ACCESSION NBR: 8111230484 DOC. DATE: 81/10/27 NOTARIZED: NO DOCKET #
 FACIL: 50-397 WPPSS Nuclear Project, Unit 2, Washington Public Power 05000397
 AUTH. NAME: AUTHOR AFFILIATION
 BOUCHEY, G. D. Washington Public Power Supply System
 RECIP. NAME: RECIPIENT AFFILIATION
 SCHWENCER, A. Licensing Branch 2

SUBJECT: Forwards response to Reactor Sys Branch request for addl info re open items, per 811007 telcon. Response will be incorporated into FSAR Amend 21.

Subject: SUPPLY SYSTEM NUCLEAR PROJECT NO. 2
NRC QUESTIONS AND OPEN ITEMS
REACTOR SYSTEMS BRANCH

FIGURE 211213-1

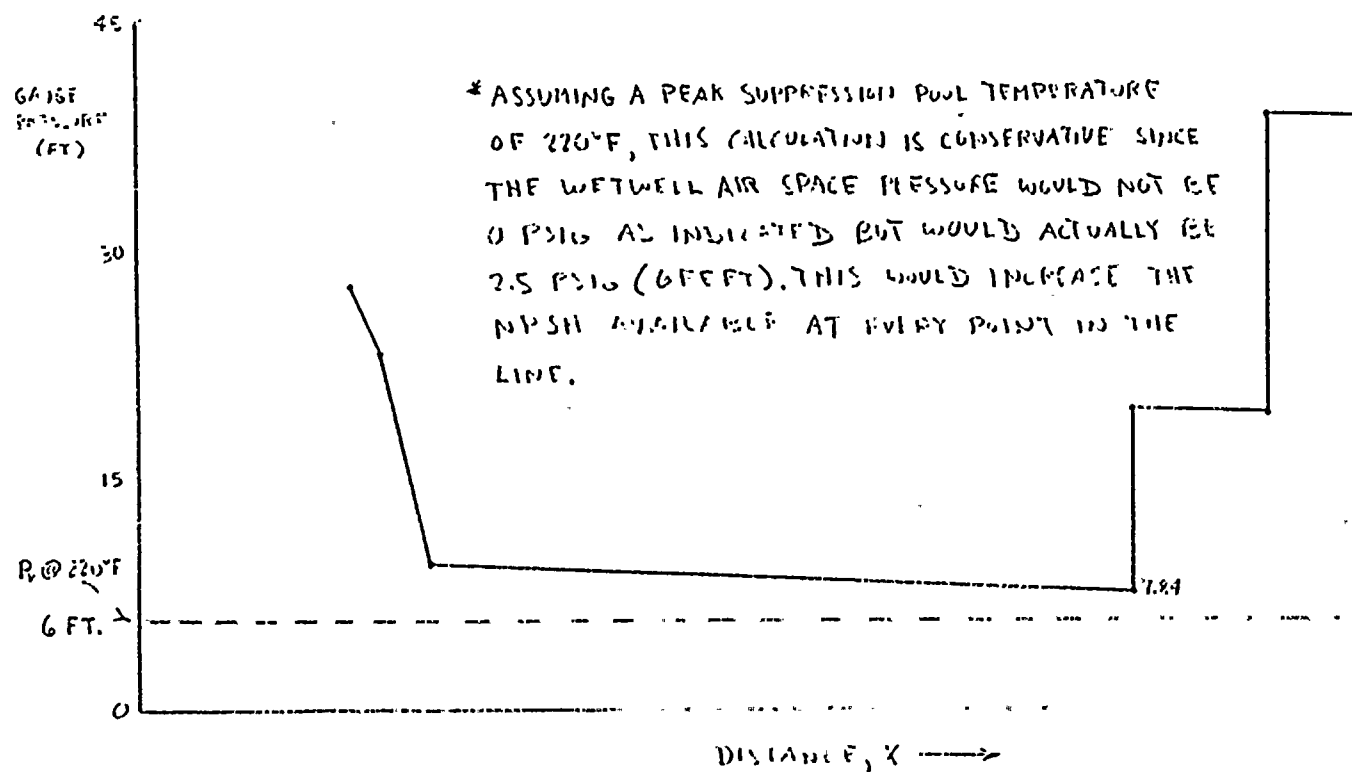
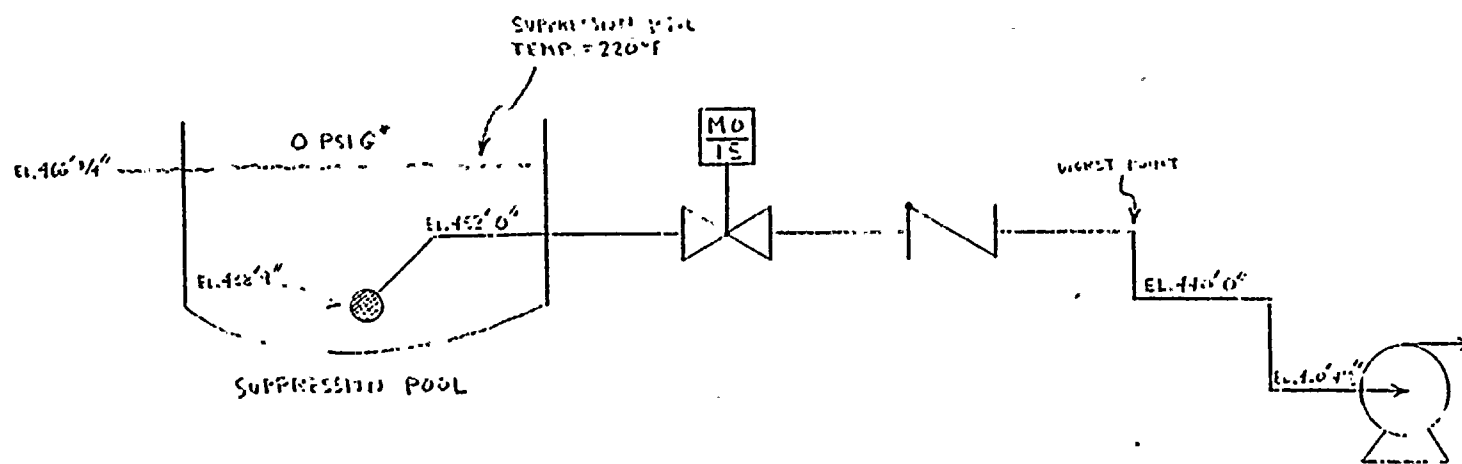
Q. 211.213

Calculations of NPSH available to ECCS pumps in BWRs are normally provided with reference to the pump suction. We are concerned that under certain post-accident conditions the potential may exist for damage to ECCS pumps from cavitation because of local flashing in the system suction lines. The potential can result, for example, from local elevation changes in the piping runs. Calculations of NPSH available at the pump suction may erroneously assume liquid continuity up to the point of pump suction. Provide an analysis with calculations which demonstrates that the NPSH available at all points in all safety-related pump suction piping is adequate to preclude local flashing and pump cavitation under the worst postulated conditions.

The ECCS systems which are involved are the RHR, LPCS, and HPCS systems. The RCIC system is also considered. Supply to the suction of the pumps comes from condensate storage or from the suppression pool. In the worst case, pump suction would be drawn from the suppression pool at high temperatures.

For each system, assuming a peak suppression pool temperature of 220°F, a plot was prepared of available NPSH versus location in the pump suction line. The HPCS system represents the worst case and is illustrated in Figure 211.213-1. At the worst point in the system, the available NPSH is 7.8+ feet which is above the 6 feet required to prevent flashing in the line. This calculation is conservative since the actual wetwell air space pressure at 220°F would be 2.5 psig (6 feet) not 0 psig as assumed per Regulatory Guide 1.1. This would provide an additional 6 feet of available NPSH at any point in the pump suction line.
